Addendum No.: 1

Date Of Addendum: 05/02/2019

Henry Abbott Technical High School
New Garage Building
21 Hayestown Avenue
Danbury, CT
BI – RT – 888

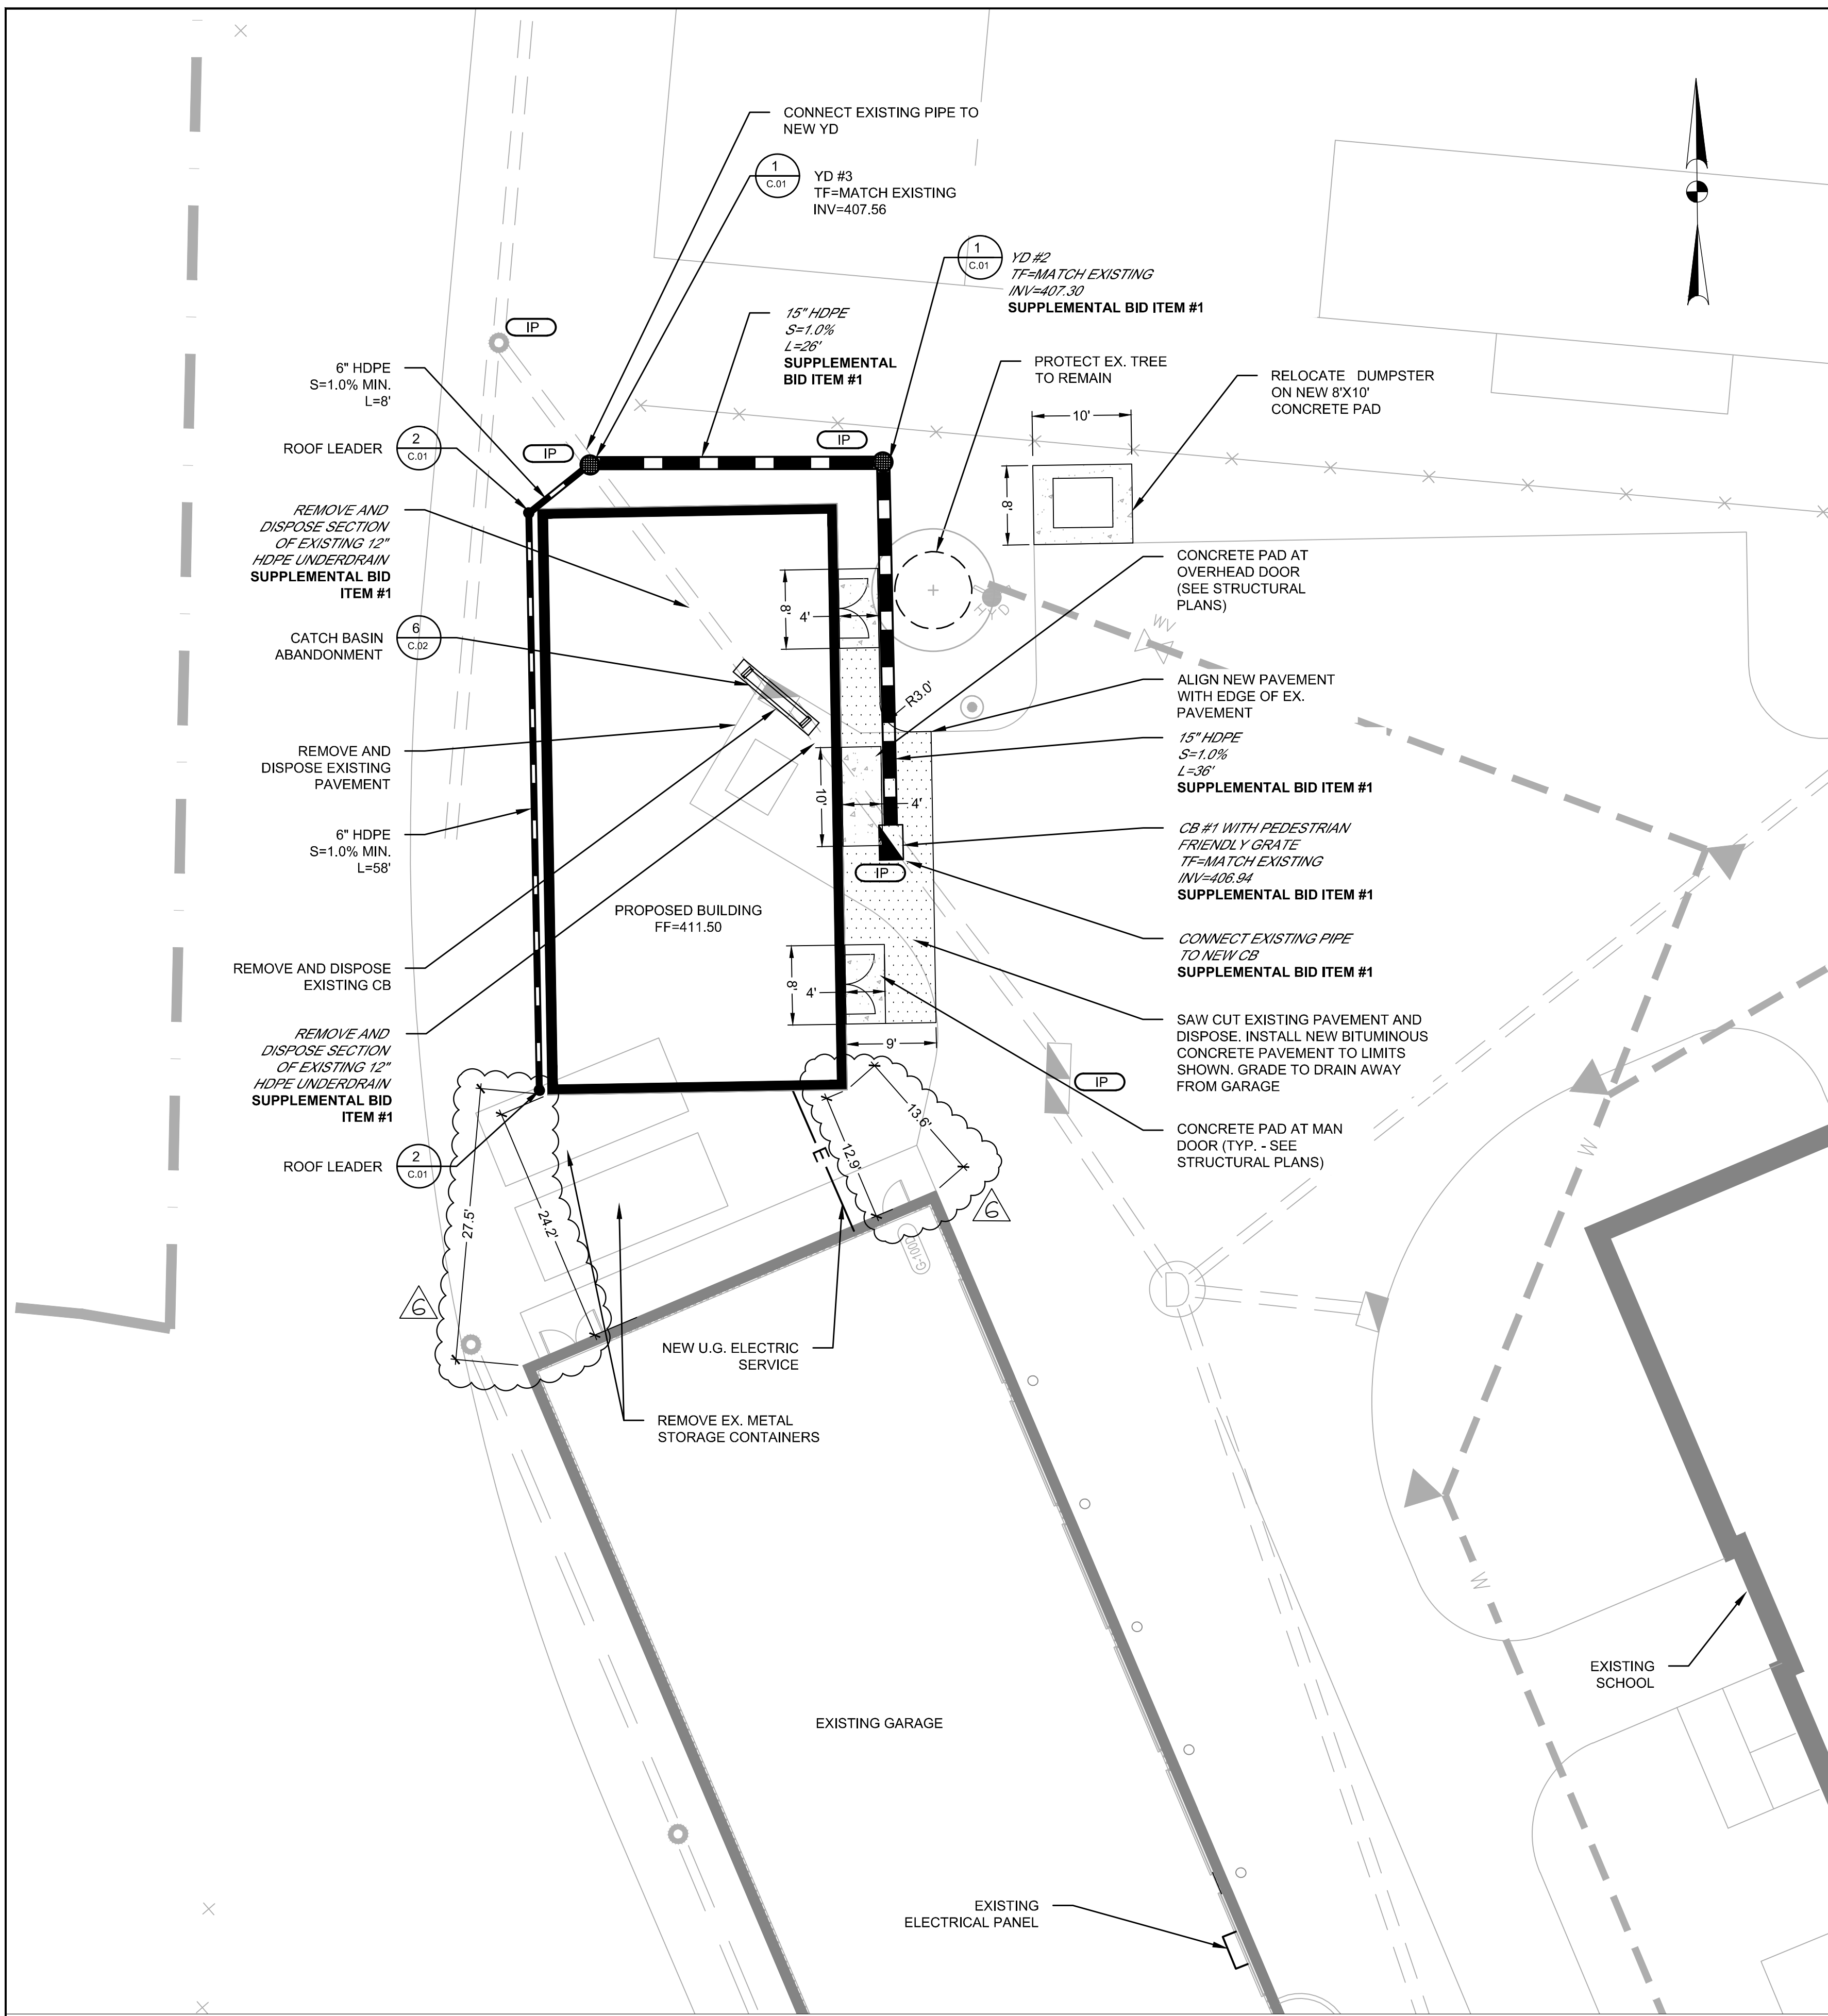
Replace Plan Drawing C.01 with attached revised (12/18/18) Plan Drawing C.01 which adds dimensions to locate proposed building on the site in reference to existing garage building adjacent to it.
